SUBJECT: Supplements 790226 submittal on primary overcurrent fault protective sys. Matl pertains to ability of protective systems to prevent heat rises as related to containment structure.

Re: Docket No. 50-275-OL
Docket No. 50-323-OL
Diablo Canyon Units 1 and 2

PRIMARY OVERCURRENT FAULT PROTECTIVE SYSTEMS
FOR
CONTAINMENT PENETRATIONS
Additional Information

FIG. 6
REDRAIN 8/7/79

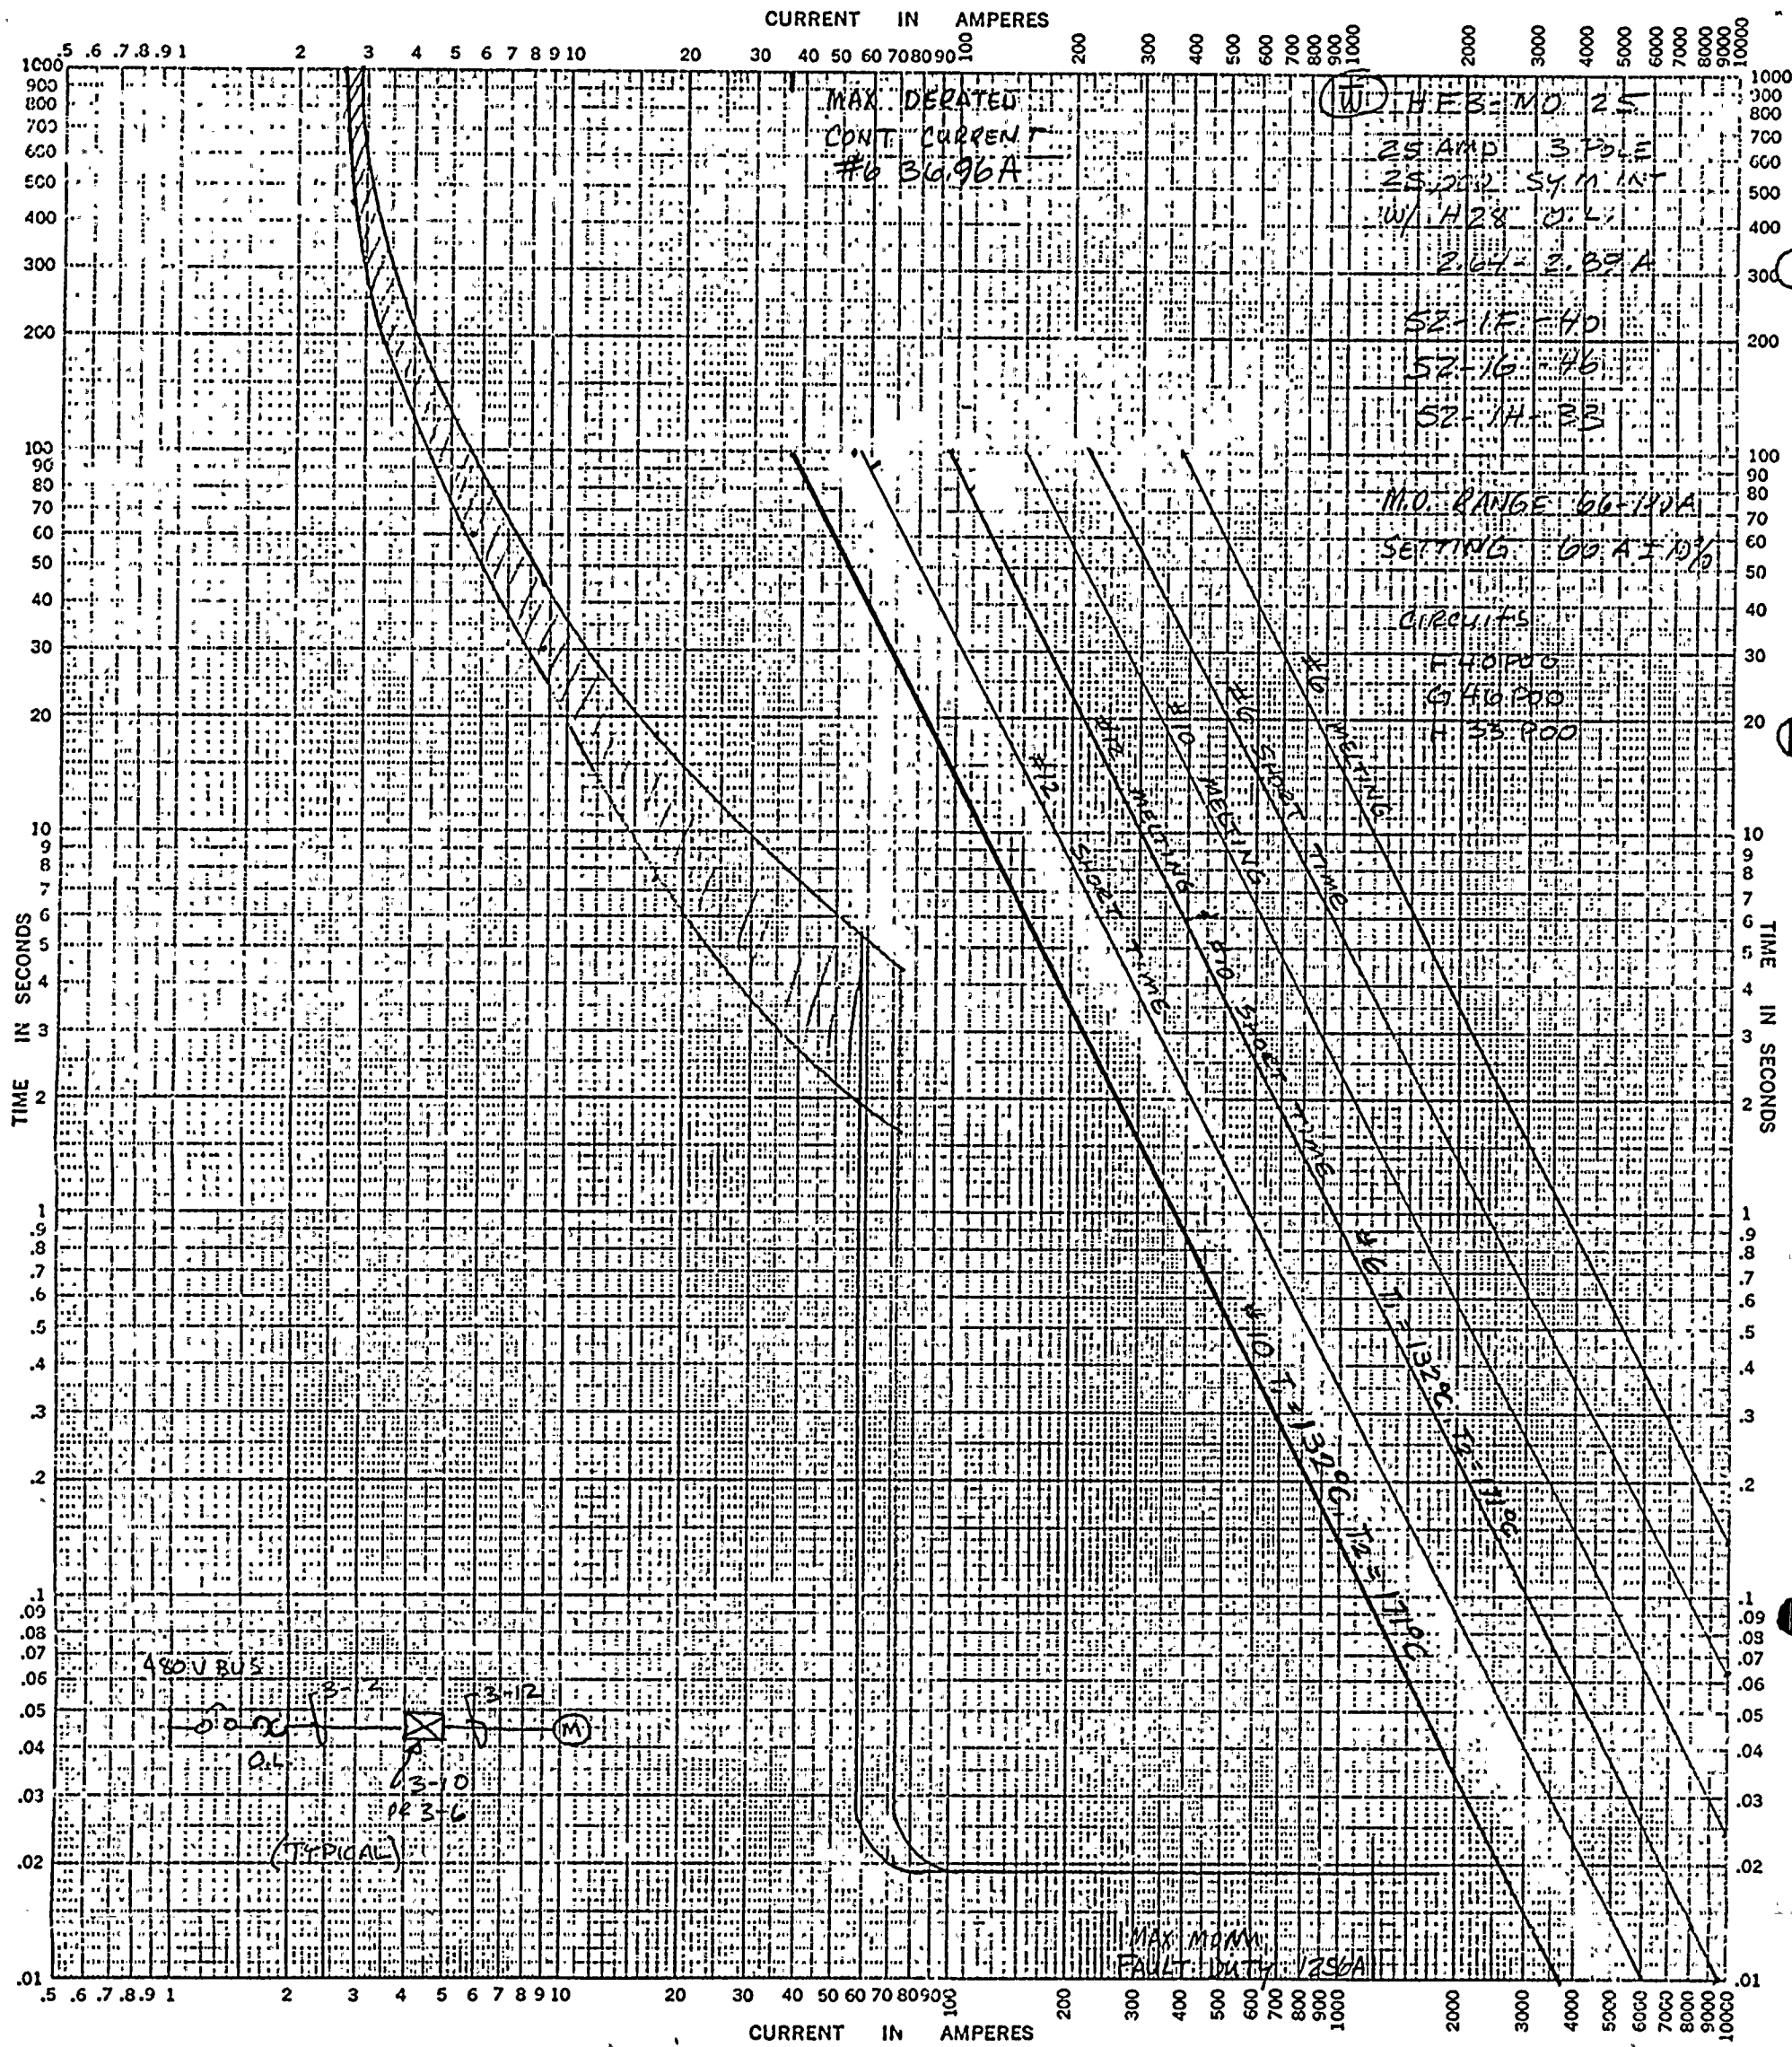
One curve, Figure 6, has been redrawn to reflect the new settings of the primary protective circuit breaker.
